Project Address: 121, 123, and 127 West Gilman Street
Application Type: Certificates of Appropriateness for demolition and new development in the Mansion Hill historic district
Legistar File ID # [32027](#)
Prepared By: Amy L. Scanlon, Preservation Planner, Planning Division

Summary

Requested Action/Proposal Summary: This development proposal requires multiple actions from the Landmarks Commission. The Landmarks Commission shall act on the request for a Certificate of Appropriateness for the following items related to Legistar #32027 as discussed in this staff report:

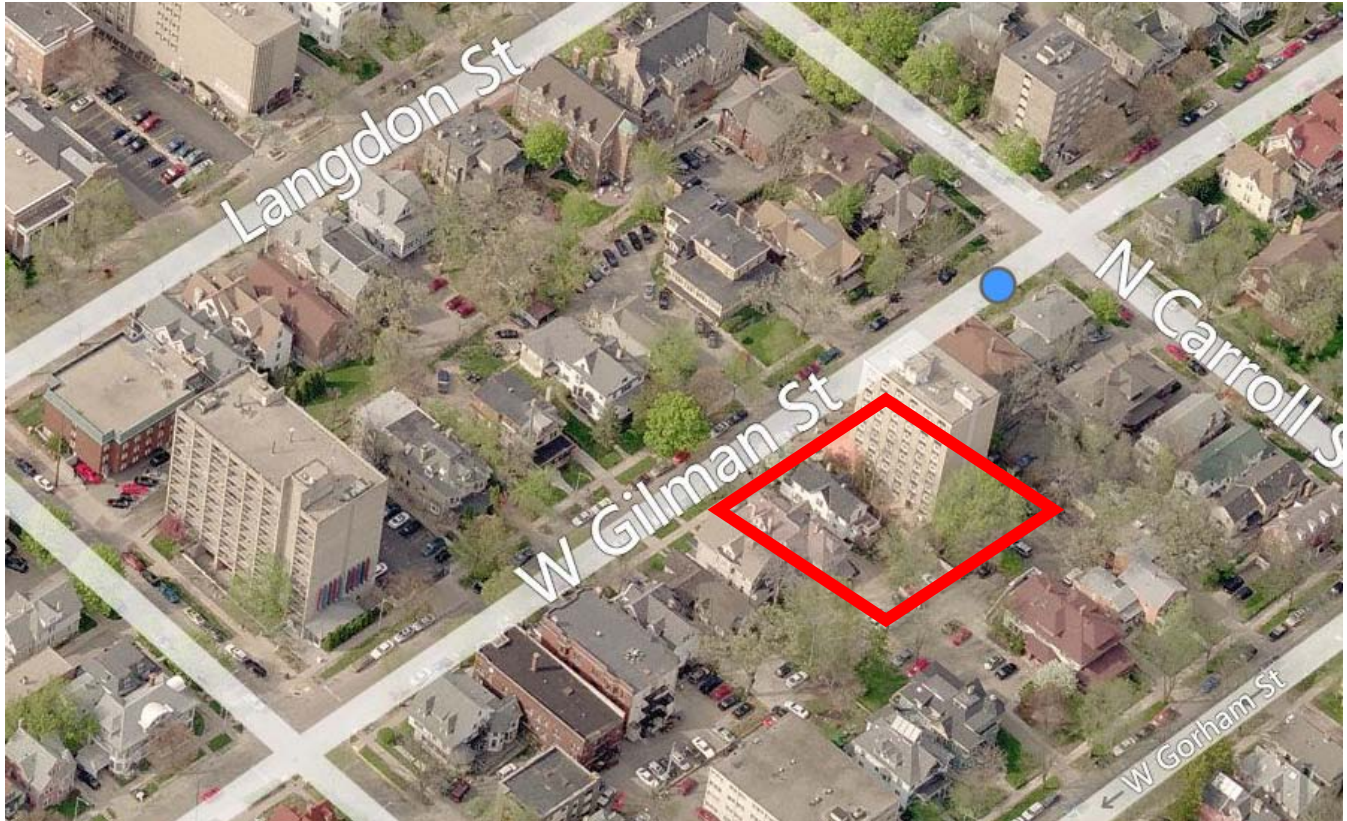
- f. The building is in deteriorated condition and a hardship is being claimed. While the property had already suffered damage by fire and foundation issues before being acquired by Steve Brown Apartments, the building was not repaired to rectify the issues and has deteriorated further. A property owner in a historic district is charged with keeping their property in good repair. The intent of this provision is to maintain the building stock in good condition so that demolition by neglect cannot be used to damage the essence of the historic district.

- g. The new structure proposed for this site may meet zoning code requirements, but it does not meet the Landmarks Ordinance. Further analysis of the new development proposal is found below.

Staff has requested that the project team investigate the relocation of this building. The maintenance and repair of buildings in the historic district is a priority for the City of Madison. To respond to this request, the project team has submitted numerous condition and structural reports which describe the condition of the structure.

Staff believes that the standards for granting the Certificate of Appropriateness for the demolition of the building at 127 W Gilman are not met and recommends that the Landmarks Commission deny the request. Staff also suggests that the Landmarks Commission discuss the relocation of the structure.
